Access Compliance Report

Public Rights-of-Way

(Curb Ramps)

Intersection ID: 28305	Main Street: COMMUNITY HOUSE RD	Cross Street: TAMARRON DR	Location: SW
ADA ID: CBD4775B2815	Ramp Type: Perp	Initial Pass/Fail: Fail	Overall Compliance: No
Codes/Mitigation Info/Possible Solution		Field Measurements/Component Compliance

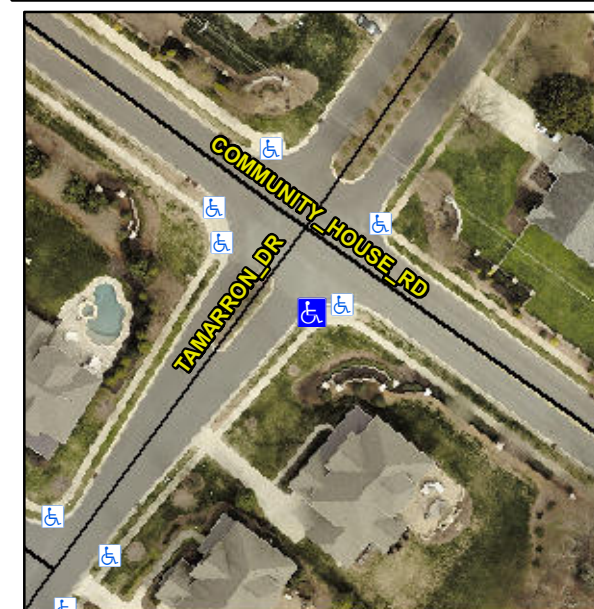
Not Found, R304.5.1, R304.2.2, R304.5.3

Compliance	Description	Data	Compliance	Description	Data
N/A	Ramp Length (in)	51.0	No	Ramp Slope (%)	9.5
No	Ramp Width (in)	47.0	No	Ramp XSlope (%)	5.1
N/A	Flare Type LT	N/A	N/A	Flare Type RT	N/A
N/A	Flare Slope LT (%)	N/A	N/A	Flare Slope RT (%)	N/A
N/A	Flare Traversable LT?	N/A	N/A	Flare Traversable RT?	N/A
N/A	Landing Length (in)	N/A	N/A	DWS Provided?	N/A
N/A	Landing Width (in)	N/A	N/A	DWS Contrast?	N/A
N/A	Landing Slope (%)	N/A	N/A	DWS Length (in)	N/A
N/A	Landing X Slope (%)	N/A	N/A	DWS Full Width?	N/A
N/A	Landing Curb? (Y/N)	N/A	N/A	DWS Offset (in)	N/A
N/A	Shared Landing?	N/A			
N/A	Gutter Ponding?	N/A	N/A	Gutter Slope (%)	N/A
N/A	Gutter Lip Ht (in)	N/A	N/A	Gutter X Slope (%)	N/A
N/A	Painted X Walk1?	No	N/A	Painted X Walk2?	N/A
	X Walk 1 Direction	To NW		X Walk 2 Direction	N/A
N/A	X Walk 1 Width (in)	N/A	N/A	X Walk 2 Width (in)	N/A
	X Walk 1 Slope (%)	2.9		X Walk 2 Slope (%)	N/A
	X Walk 1 X Slope (%)	6.0		X Walk 2 X Slope (%)	N/A

Remove & Replace Entire Ramp.
